No. 90-6

Shift Plate Inspection

All MCM V6/V8 Alpha One or Bravo One or Bravo Two Engines
Serial Number 0C858947 - 0C877307

Figure 1.

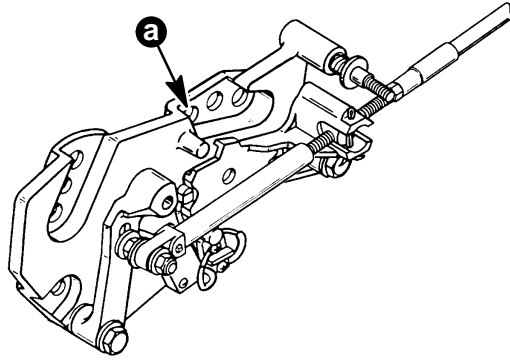
When servicing these engines, check to see if shift plate is tight against exhaust elbow in area of bolt (a) shown in Figure 1.
